Department of Infrastructure,  
Local Government and Planning

Our reference: 1710-1925 SRA  
Your reference: D/114-2017

**Referral agency response—with conditions**

Development permit	Material change of use for Service Station
--------------------	--

SITE PLAN

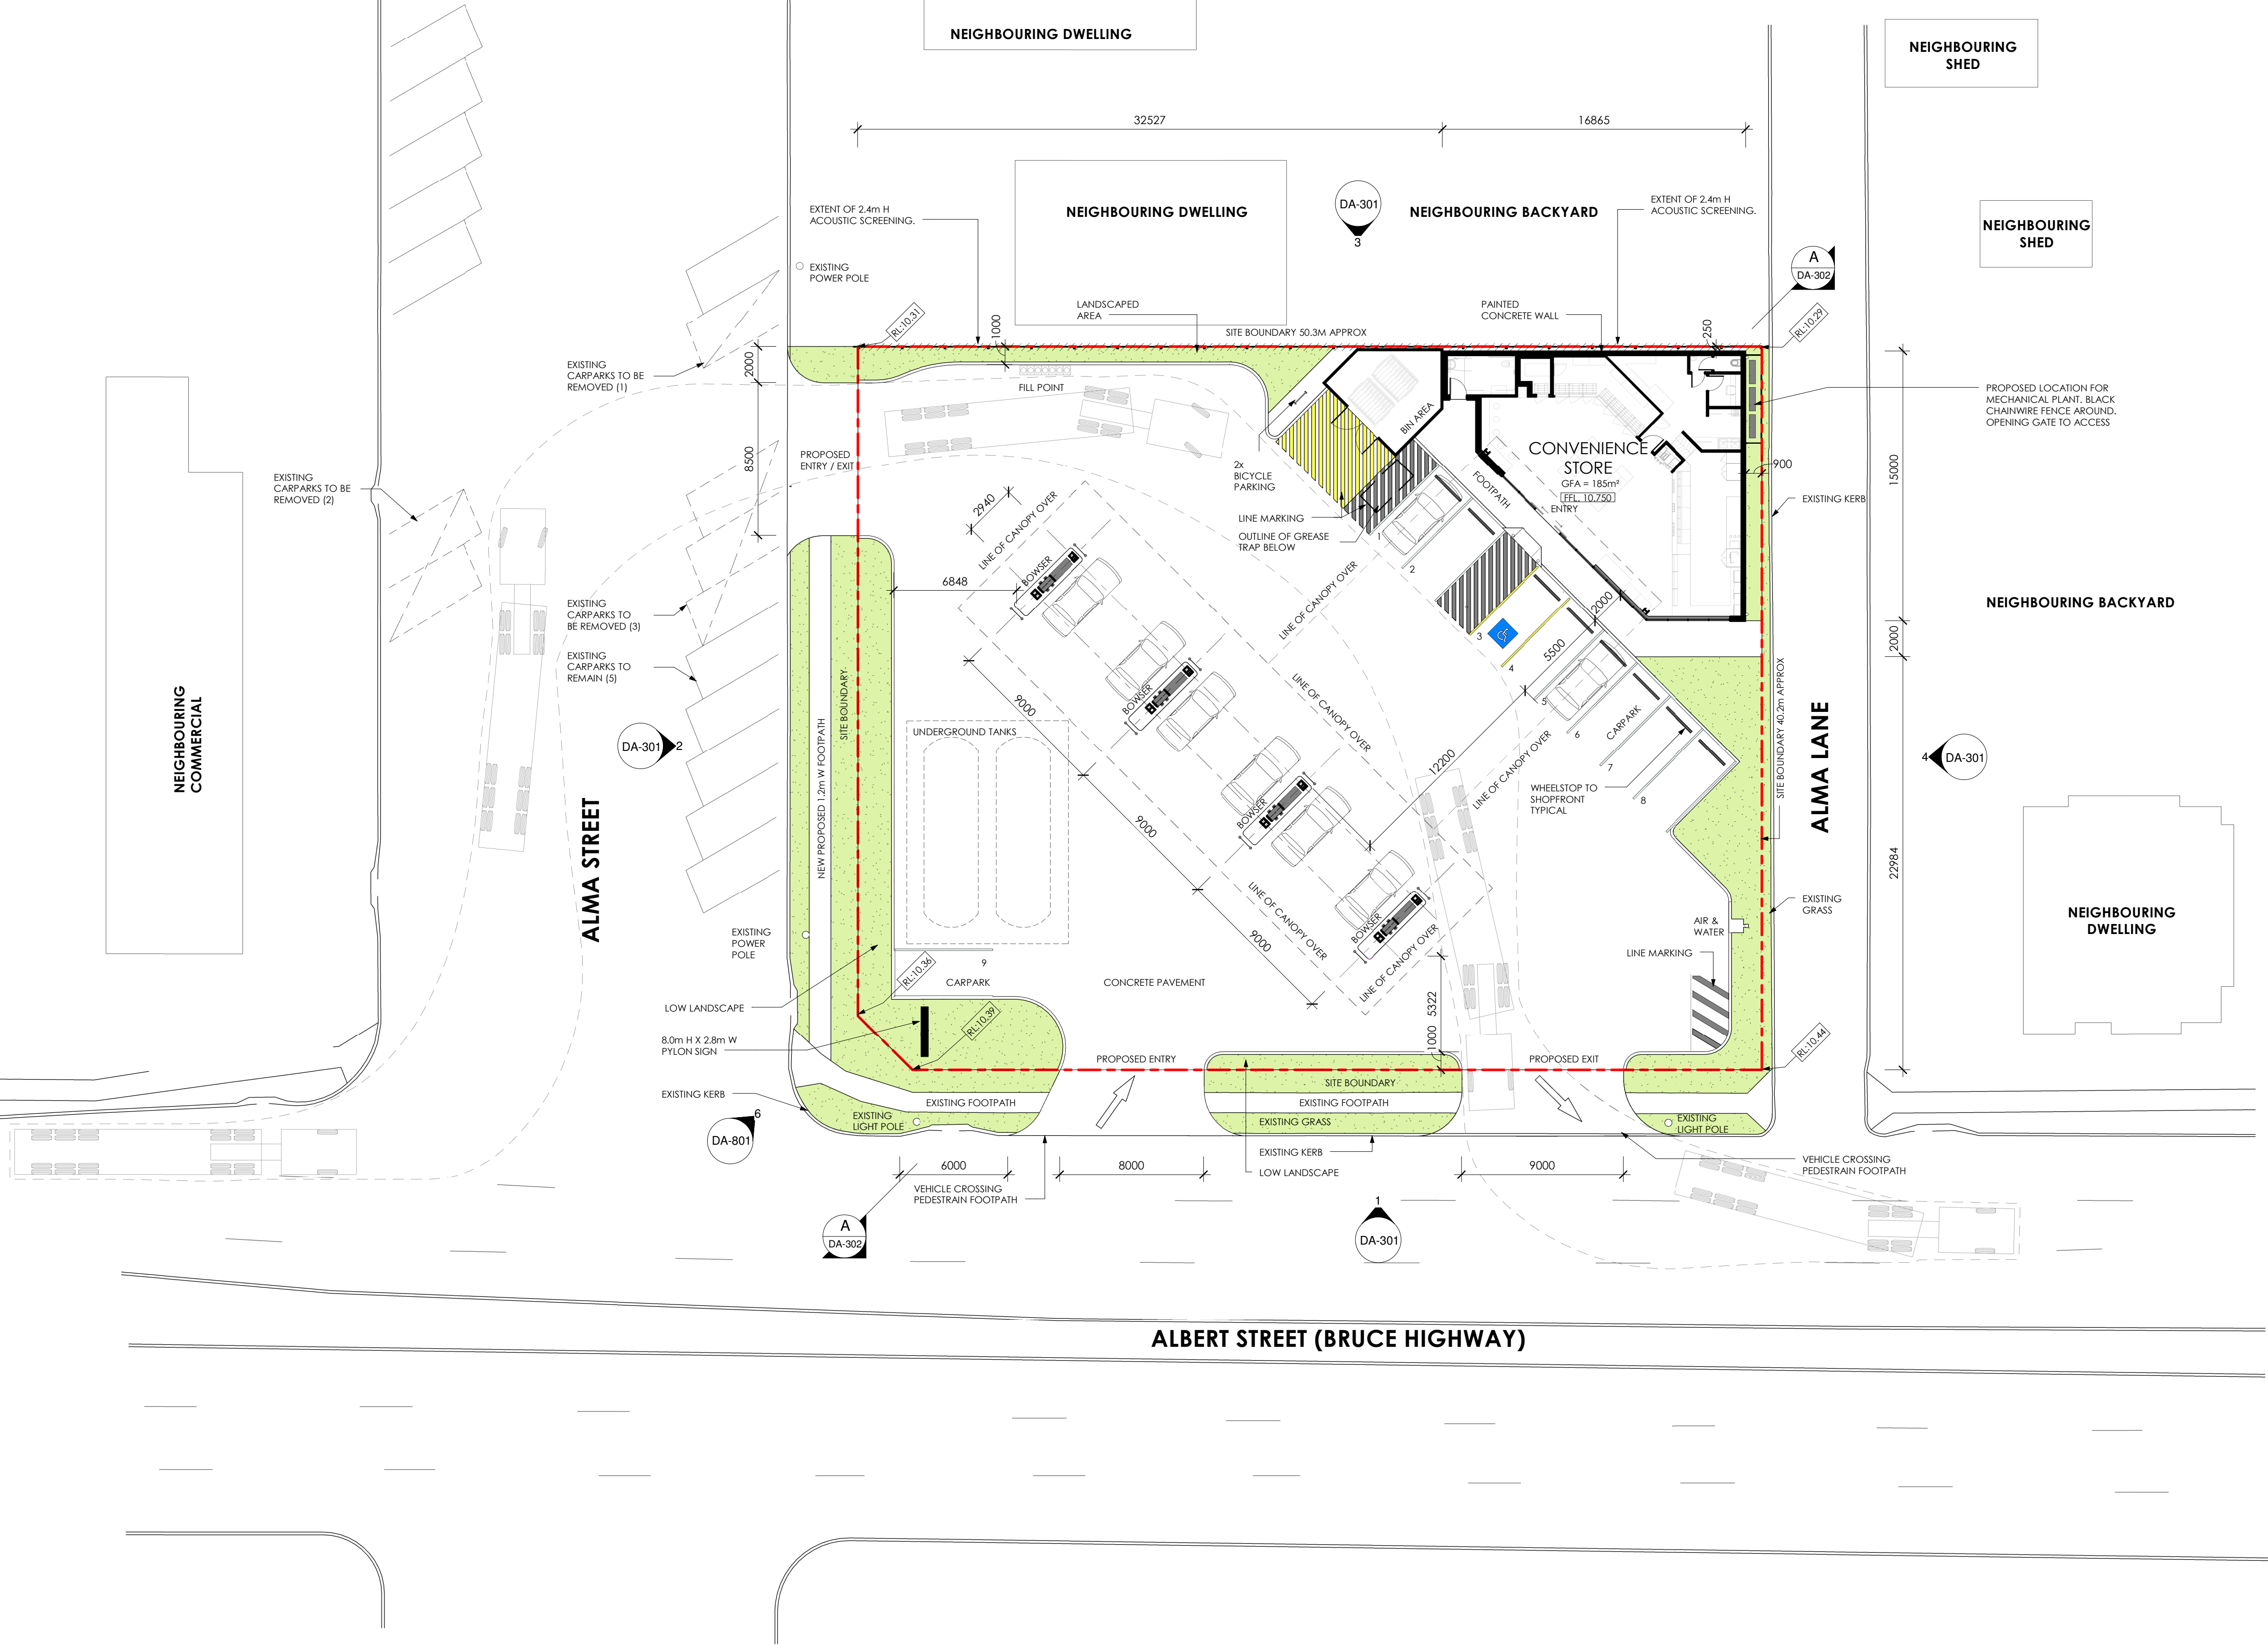
1.	<p>The road accesses must be carried out generally in accordance with the following plan:</p> <ul style="list-style-type: none"> <li>• Site Plan compiled by Leffler Simes Architects, dated August 2017, reference DA-102, revision A.</li> </ul>	At all times.
